## **Appendix IV**

*CLP's Electricity Transformer Room Requirements*

**TRANSFORMER ROOM AND CABLE DUCT LAYOUT PLAN - G/F**  
SCALE: 1:100@A1  
DATE: 16 May 2024

**RESIDENTIAL DEVELOPMENT AT 8 KA SHUE ROAD, SAI KUNG**  
**ELECTRICAL SUPPLY APPLICATION**

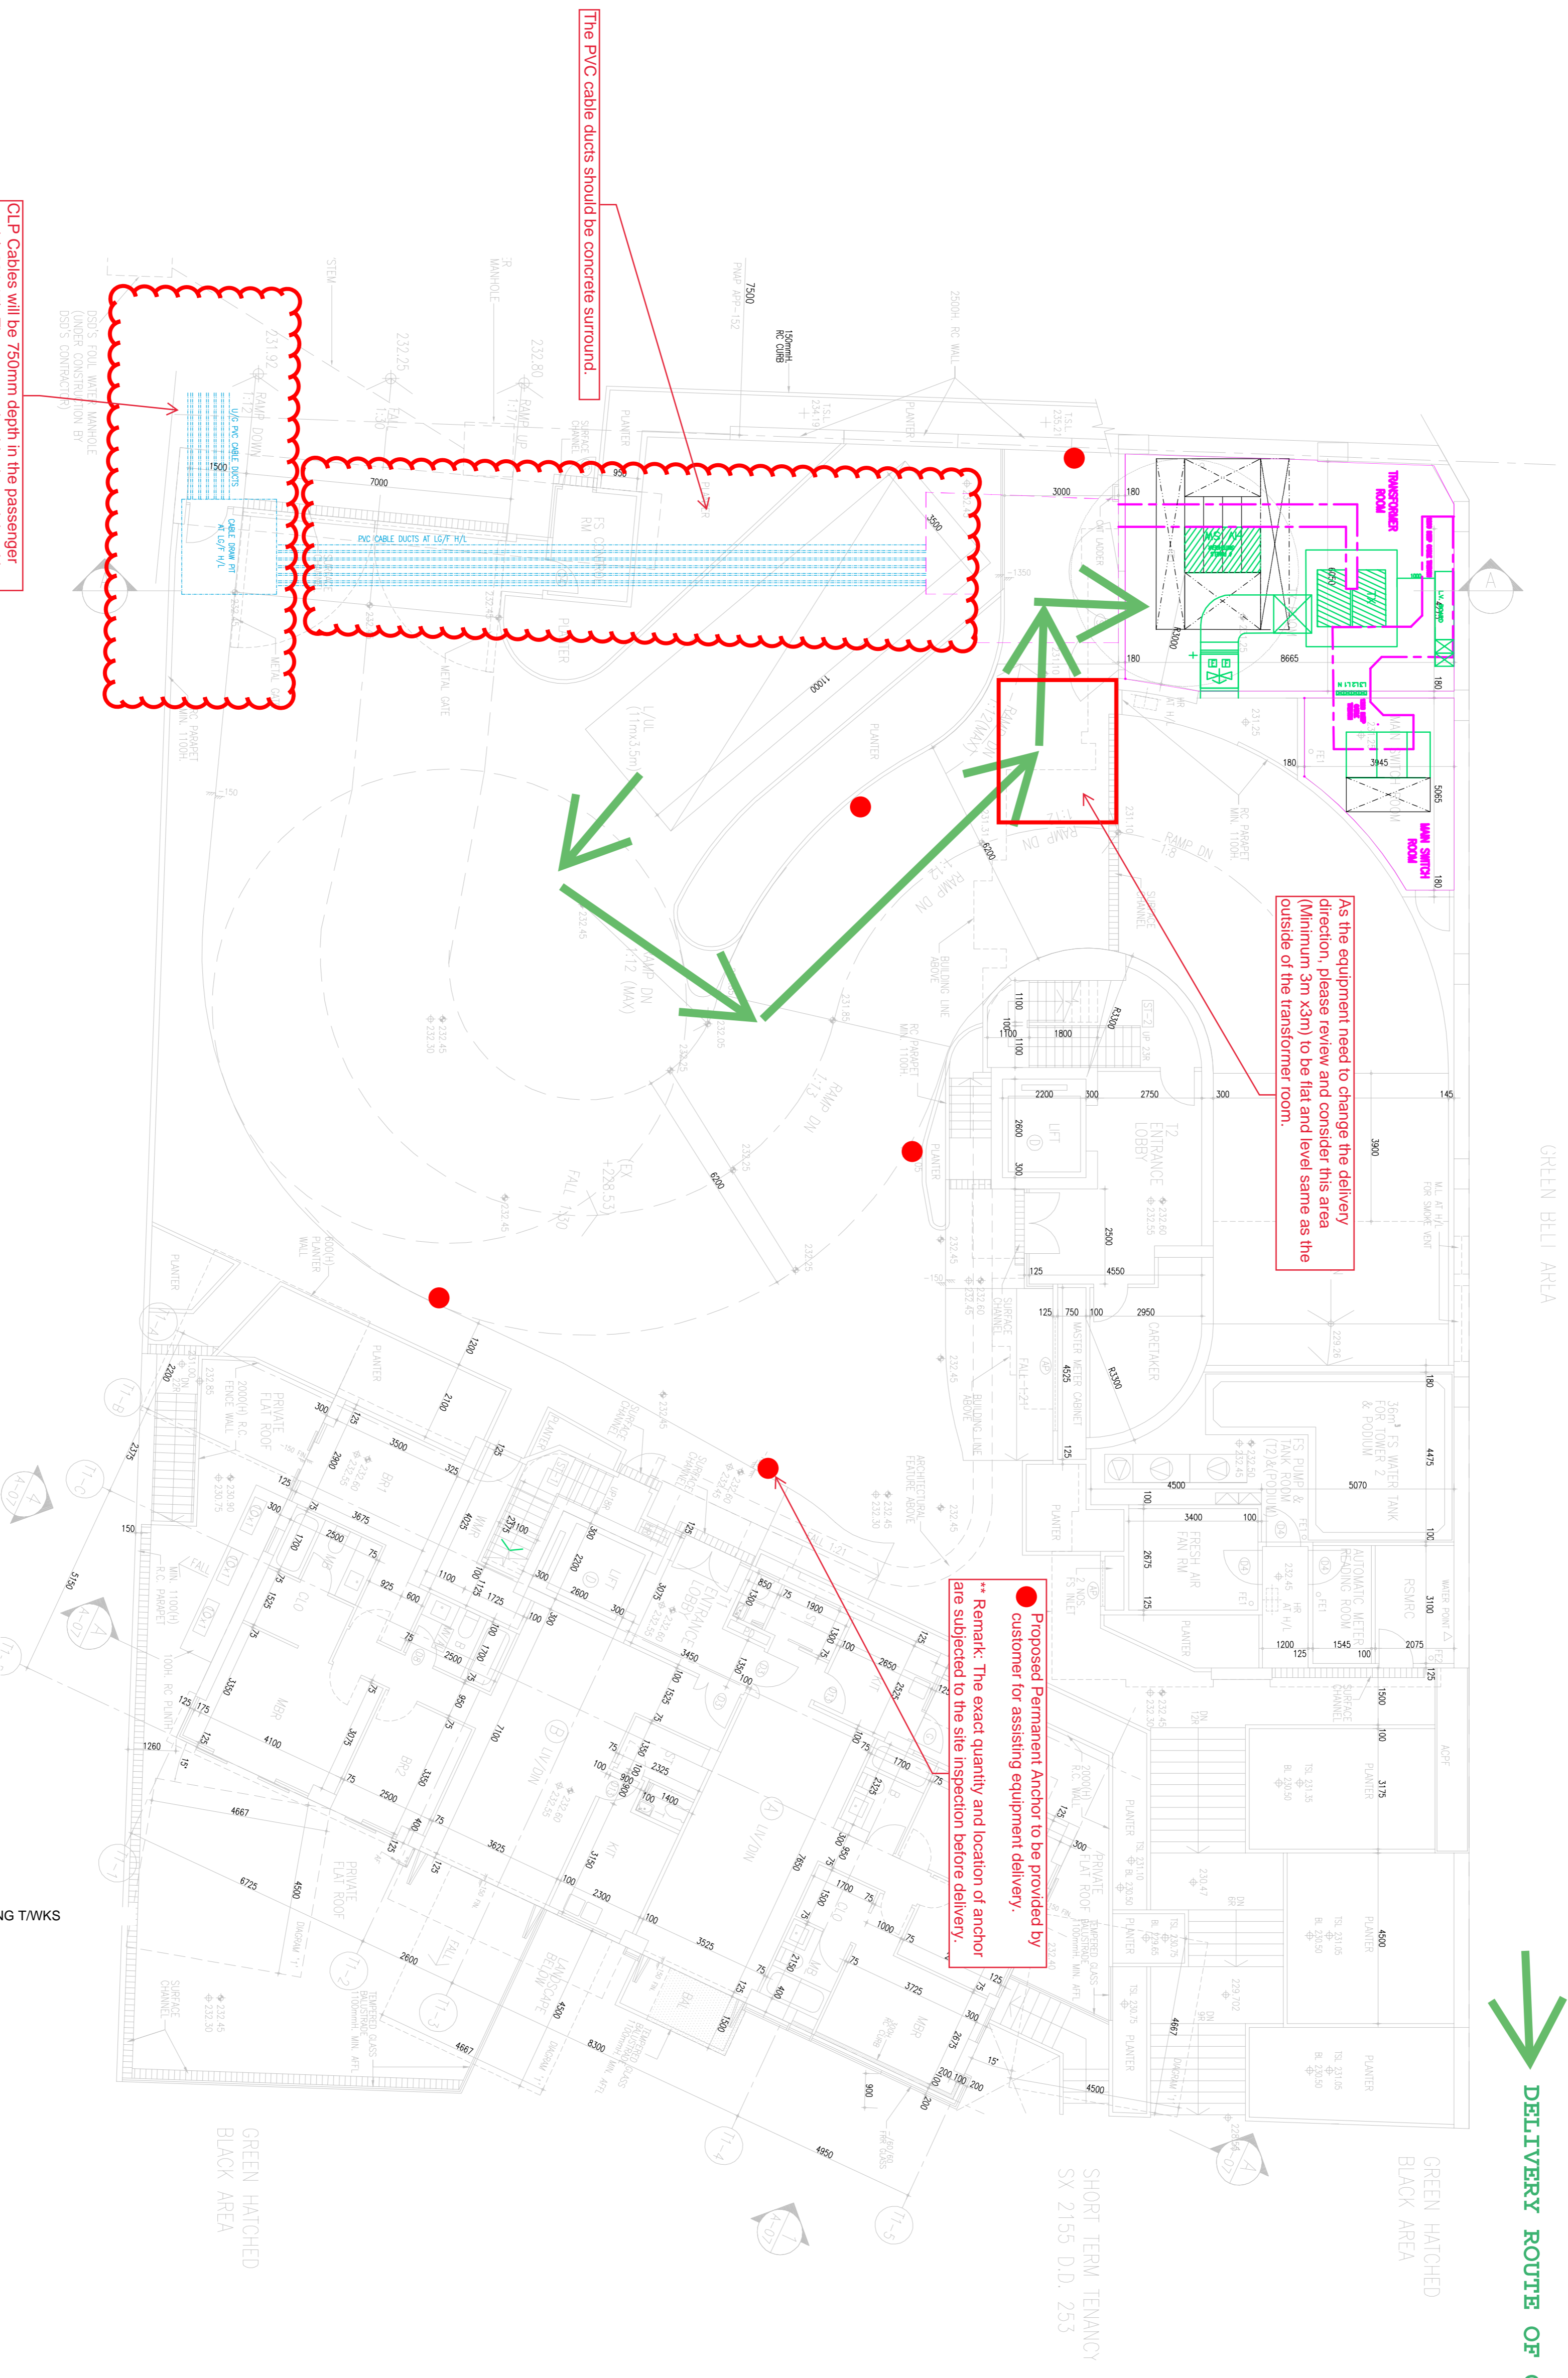
As per the provided drawings, the proposed delivery route from loading area to transformer room are 1:12 gradient (fulfil the COP101 requirement).

The equipment needs to change the delivery direction near the TX room, so please consider the delivery path near TX room to be flat and same level to TX room.

For this delivery path, permanent anchors should be provided by customer for assisting equipment delivery. The exact quantity and location of anchor are subjected to the site inspection before delivery. Please coordinate with construction team on site.

Moreover, the level of the cable draw pit is not fulfilled the requirement in COP101. Also, the PVC cable ducts at LG/F H/L should be concrete surround. Please review and revise.

DELIVERY ROUTE OF CLP'S EQUIPMENT

As the equipment need to change the delivery direction, please review and consider this area (Minimum 3m x3m) to be flat and level same as the outside of the transformer room.

Proposed Permanent anchor to be provided by customer for assisting equipment delivery.  
Remark: The exact quantity and location of anchor are subjected to the site inspection before delivery.

The PVC cable ducts should be concrete surround.

CLP Cables will be 750mm depth in the passenger road (-231, 17). The proposed cable draw pit levels not fulfilled the requirement in COP 101.
